Mehnaz Styles & Craft Ltd. (New)

Industry Sl. No.: 56, Ward No: 06, Tongabari, Ashulia, Savar, Dhaka
(23.898356, 90.323207)

14th June 2022

Observations

Load Limit Table in Load plan

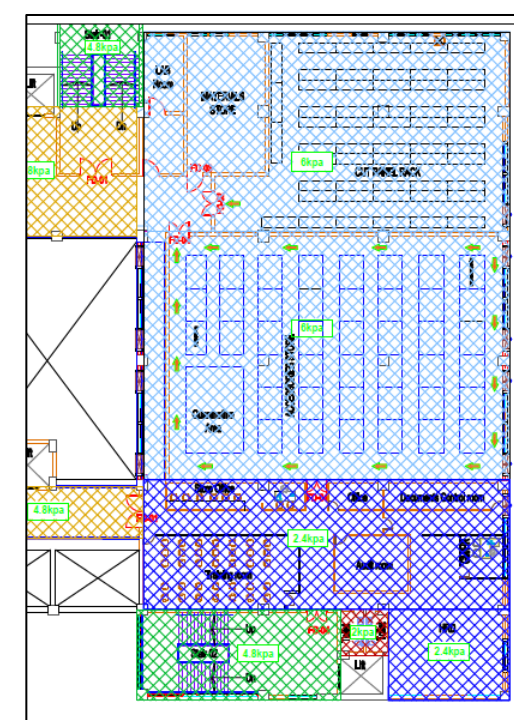
Mismatch between design report and floor loading plan

Storage at 4th floor

6 kPa live load shown in the load plan of 1st floor of part-B

Load For part-B: 5 kPa floor live load has been considered in the design report for 2nd to 6th floor. But in load plan, 6 kPa has been considered in all the storage area of 1st to 3rd floor and 5th floor. Again at 4th floor, 4 kPa live load has been considered in load plan for sewing section. But storage was found in 4th floor level. Factory engineer is required to update the floor loading plan and design report following BNBC loading requirements.

4 kPa has been considered in software-based analysis model for Part- A

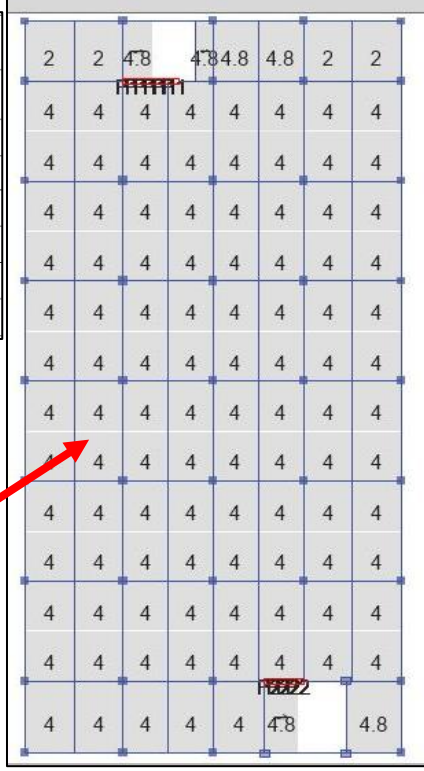
For part-A: The live load of light manufacturing has been considered 4 kPa in the software analysis model and live load plan for all floor levels where in the design report, 6 kPa live load has been considered at 1st floor and 5 kPa considered for upper floors. Factory engineer is required to update the floor loading plan, software-based analysis model and design report following BNBC loading requirements.

Flange width of steel column 200 mm

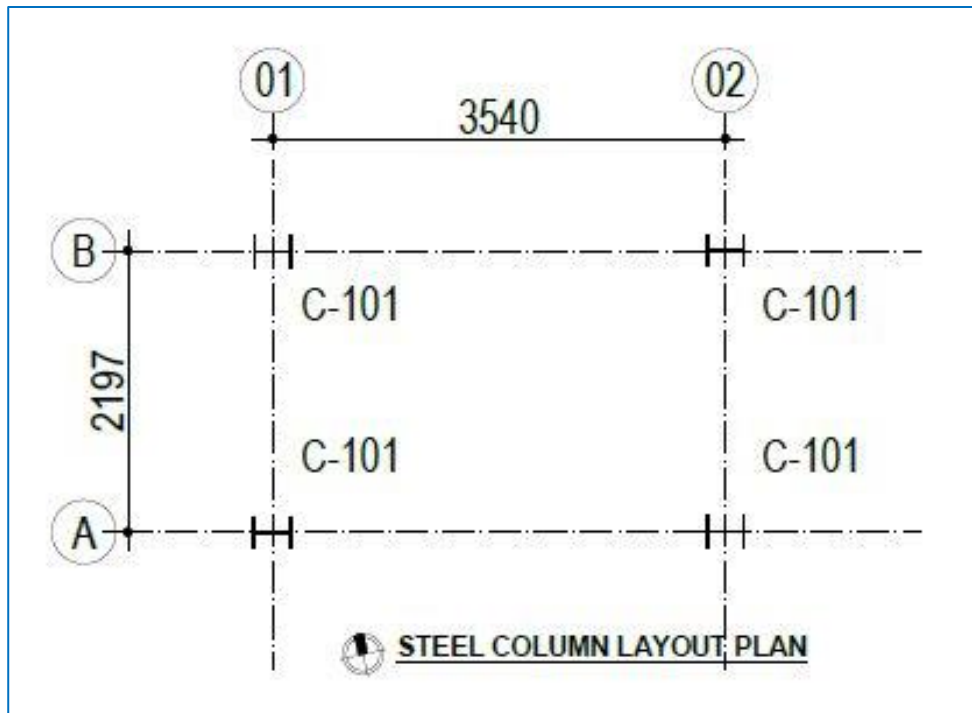
Mismatch in drawing (Steel Stair)

The flange width of stair steel column was found 200mm. Whereas as built drawing shows 250 mm. Building engineer is required revised the as-built drawing as per on site condition.
